From: Roads Eastern Srit
Sent: 11 March 2015 09:27
To: 'Anne.Madden@sustrans.org.uk'
Subject: York Street Interchange Formal Consultation

YORK STREET INTERCHANGE PROPOSALS

Re: York Street Interchange EIA

Figure 8.4 - Belfast City Centre Cycle Routes

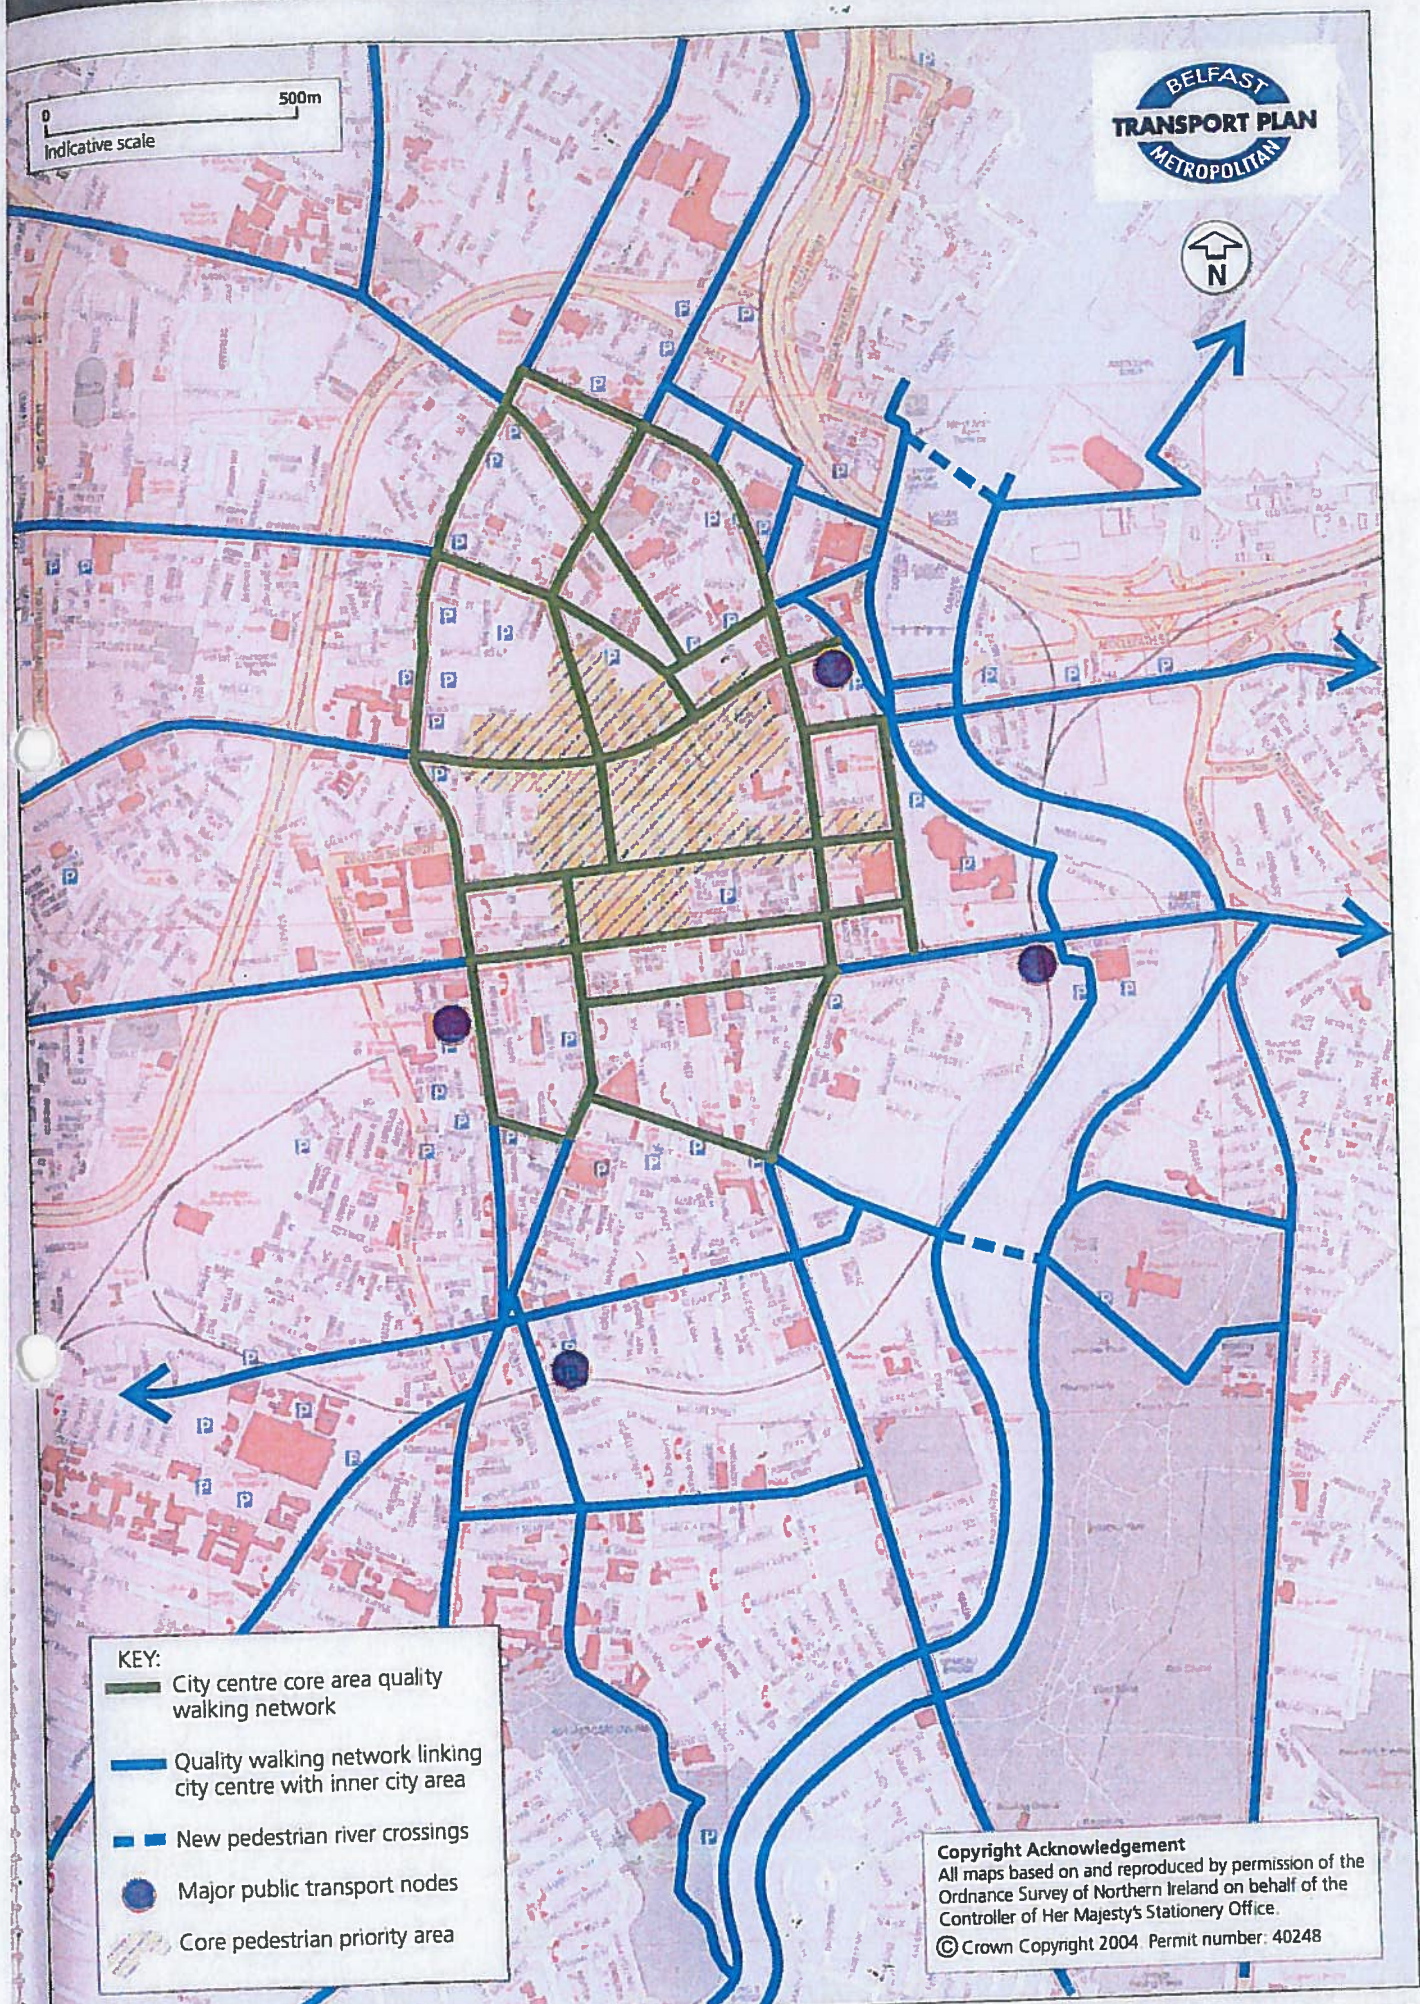
- (i) The Proposed Scheme fails to recognise and provide for the cycling network illustrated in Figure 8.4, Belfast City Centre Cycle Paths (Appendix II).
- (ii) The Proposed Scheme fails to recognise and provide for quality walking routes, as illustrated in Figure 8.3, Belfast City Quality Walking Route Network (Appendix III).
- (iii) The Belfast Metropolitan Transport Plan goes on to set out key design features of the Cycle Network.
